DECISION OF THE PLANNING ADMINISTRATOR

CLASS 3 SITE PLAN REVIEW / CLASS 2 ADJUSTMENT CASE NO.: SPR-ADJ25-17

REQUEST: A consolidated application for a Class 3 Site Plan Review for a new US Market gas station and convenience store, including fueling stations and associated site improvements, on Lot 1 of Kuebler Village Subdivision, with six Class 2 Adjustments to:

LOCATION: 4900 Block of 27th Ave SE, Salem OR 97302

ARCHITECTURAL
SITE PLAN

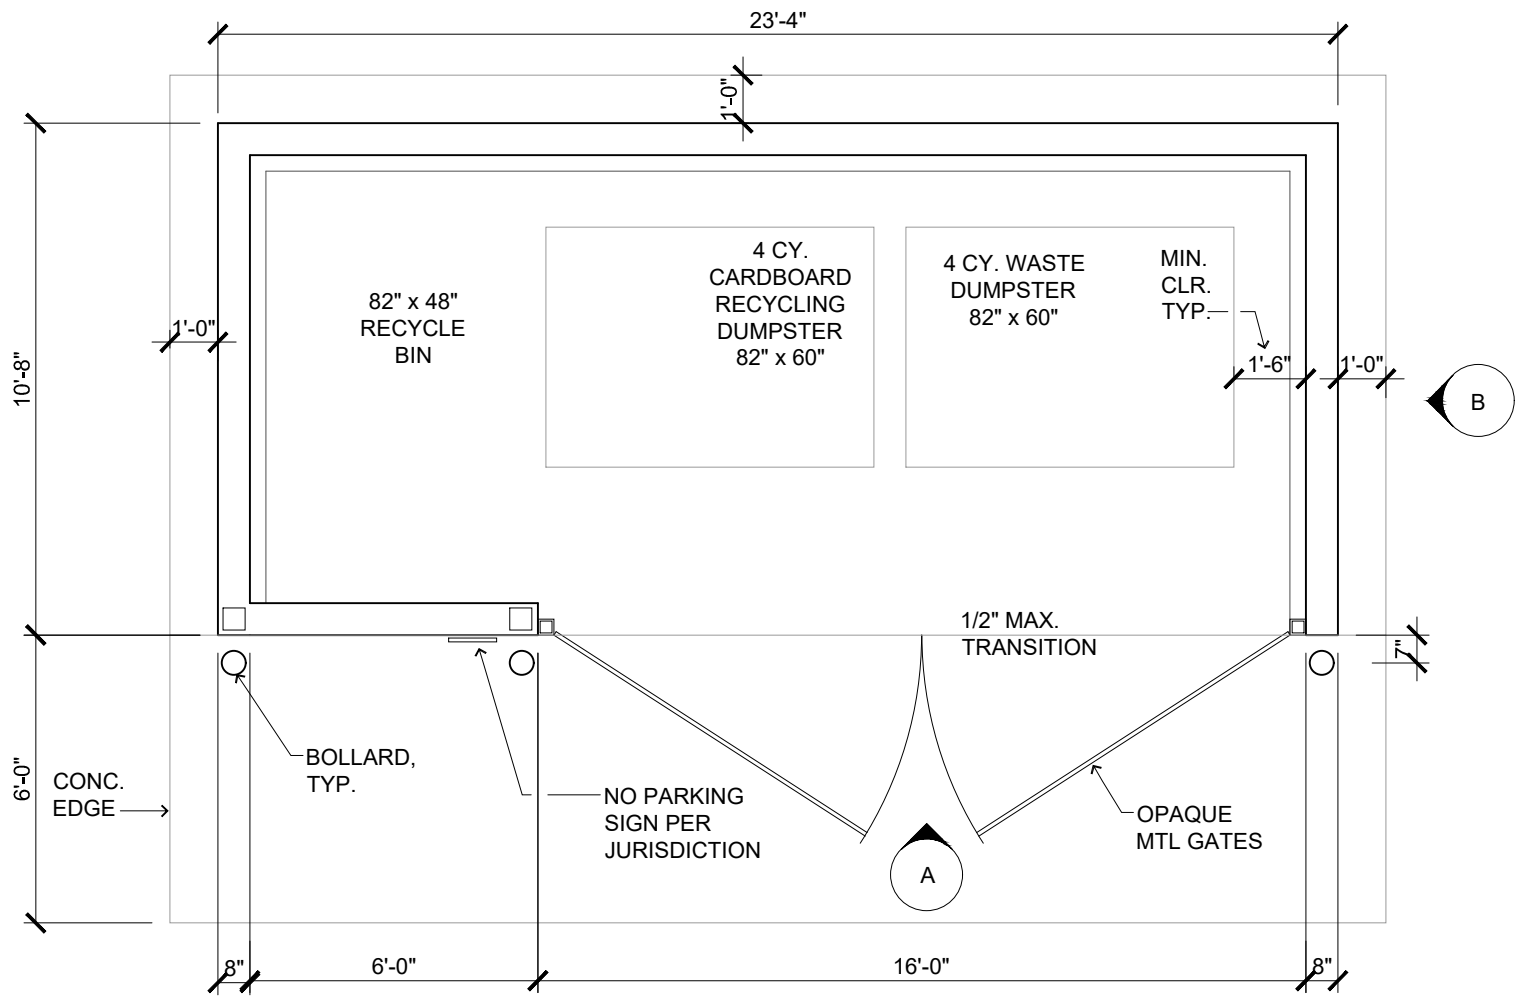
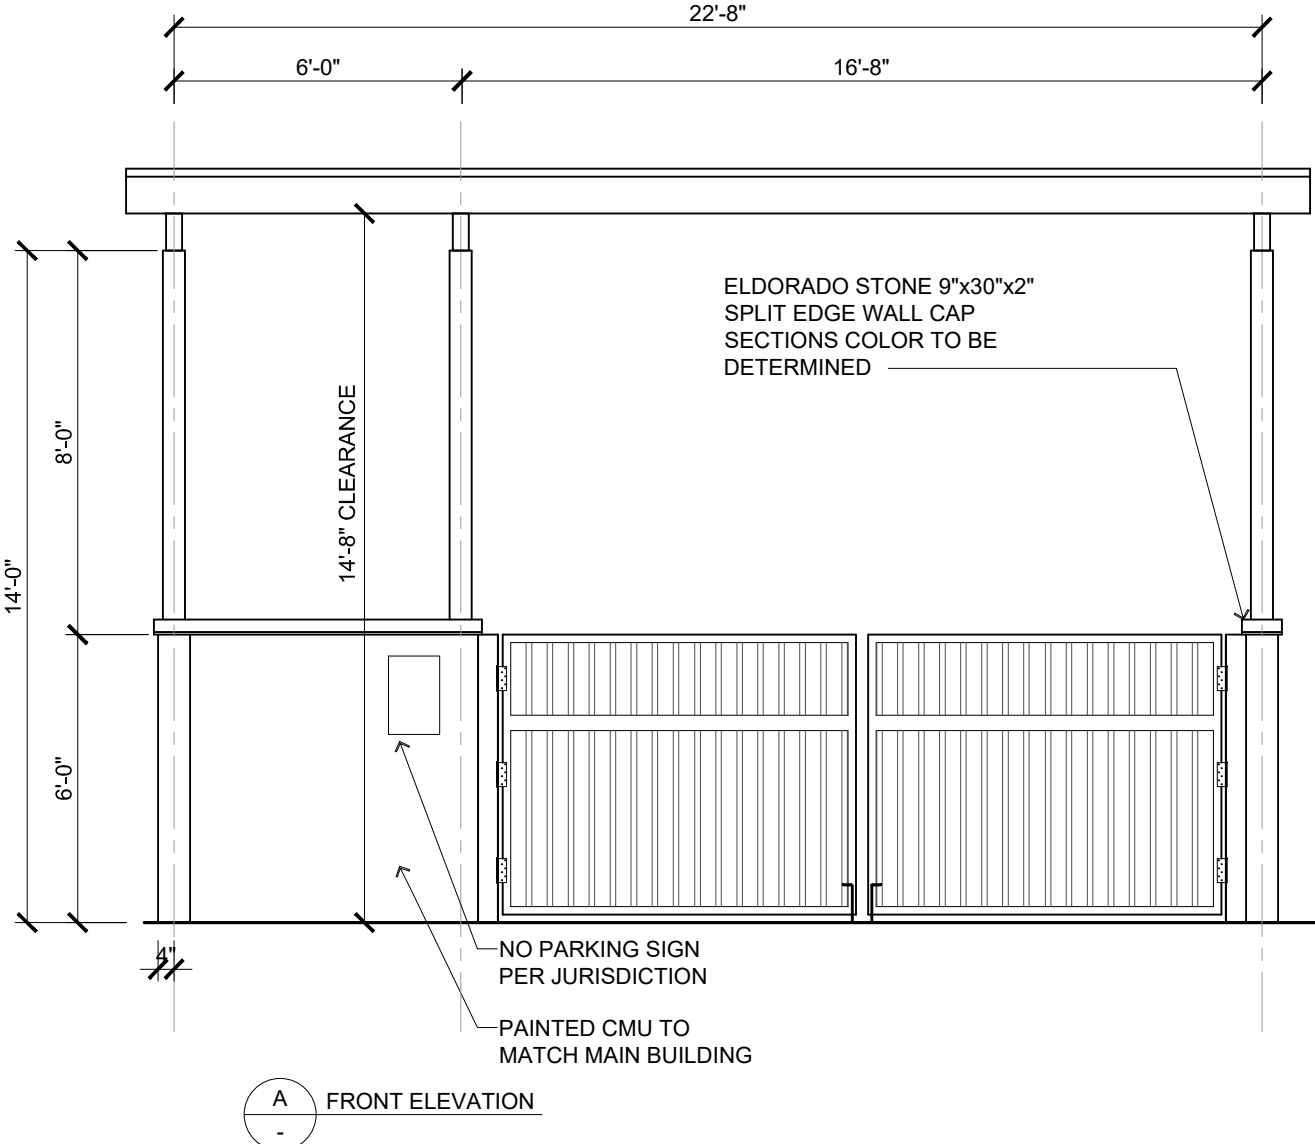
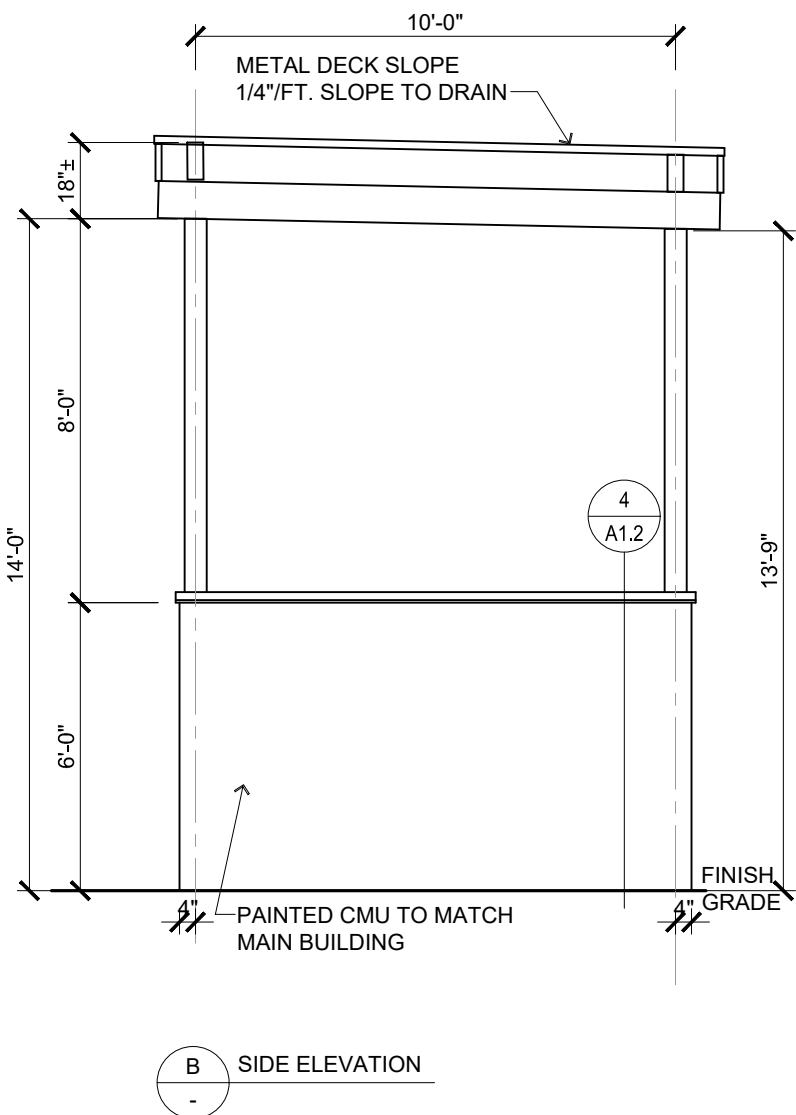
Finding: The applicant's development plans indicate a four-inch-thick concrete pad for the trash enclosure. The concrete pad area extends a minimum of one foot beyond the sides and rear of the receptacles, and a minimum of three feet beyond the front of the receptacles. The proposal includes two receptacles which face each other and have more than four feet between them. The proposal meets the standard.

Finding: The applicant's development plans show receptacles greater than two cubic yards, with at least 18 inches provided between the receptacles of the side walls. The proposal meets the standard. Receptacles will not be placed within 5 feet of a building or structure.

Finding: The applicant's development plans show receptacles greater than two cubic yards, with at least 14 feet of unobstructed overhead or vertical clearance for servicing, as no cover is proposed for this enclosure. The proposal meets the standard.

Finding: The applicant's development plans show the proposed solid waste service areas will be screened with six-foot-tall sight-obscuring fences and gates. The proposal meets the standard.

Finding: The trash enclosure plans show the enclosure constructed of masonry fencing material and indicate that a curb is provided 12 inches inside the perimeter of the enclosure walls to prevent damage from receptacle impacts consistent with this standard.

Finding: The proposed site plan shows vehicle operation areas a minimum of 45 feet in length and 16 feet in width, perpendicular to the enclosures and extending into vehicle maneuvering areas. The proposal meets the standard.

Finding: The proposed site plan shows vehicle operation areas which are coincident with parking lot drive aisles, and located adjacent to a fire truck turnaround which meets the minimum dimensions and turning radius for collection service. The proposal meets the standard.

Finding: The proposed off-street parking spaces dimensional requirements for compact and standard vehicle parking spaces established in Table 806-5. The southern parking area complies with the minimum aisle width established in Table 806-5, although the eastern parking area does not appear to meet the standard. The plans show 14-feet of pavement behind the compact spaces and future development providing the remaining 10-feet of maneuvering required. In order to meet the standard a condition of approval is required to construct the entire 22-feet of maneuvering behind the spaces on the eastern side of the building. This condition will require an additional adjustment to be reviewed for the required five-foot setback on the eastern side of the property line. This condition will be address below with the already requested adjustment to the west side of said property line.

Finding: The applicant's site plan indicate that dimension standards set forth in Table 806-6 will be met, all compact spaces are shown to be marked as well as handicap spaces. The applicant has not provided a lighting plans, therefor the following condition applies:

Finding: The site plan indicates the proposed bicycle parking is within 50 feet of a primary entrance; therefore, this standard is met.

Finding: The site plan indicates inverted style bike racks will be provided. The proposed bike racks conform to material requirements of SRC 806.060(e).

Finding: The site plan indicates 7,504 square feet (17.4 percent) of landscaped area is proposed, requiring a minimum of 857 plant units ($7,504 / 20 = 375.2$). Of the required plant units, a minimum of 150 plant units shall be trees ($375 \times 0.4 = 150$). The applicant has provided a preliminary landscaping plan which shows the areas which are to be landscaped. The plan indicates a total of 407 plant units provided, 165 of which are trees. The following condition applies:

- Condition 3:** At the time of building permit, pedestrian paths shall meet design and materials standards of SRC 800.065(c).
- Condition 4:** At the time of building permit, the applicant shall construct 22-feet behind the compact parking spaces on the eastern side of the building.

- Condition 5:** At the time a building permit, a lighting plan for the off-street parking and vehicle use areas shall be provided meeting all standards of the Salem Revised Code.

- Condition 6:** At the time of building permit review, the applicant shall provide a full landscape plan demonstrating how the development site meets Type A landscaping.

- Condition 9:** Prior to issuance of a Building Permit, the Kuebler Village Subdivision Plat (SUB-UGA-ADJ-DAP24-03) shall be recorded.
- Condition 10:** At the time of building permit, the landscaping plans shall include 17.4% of the site landscaped.
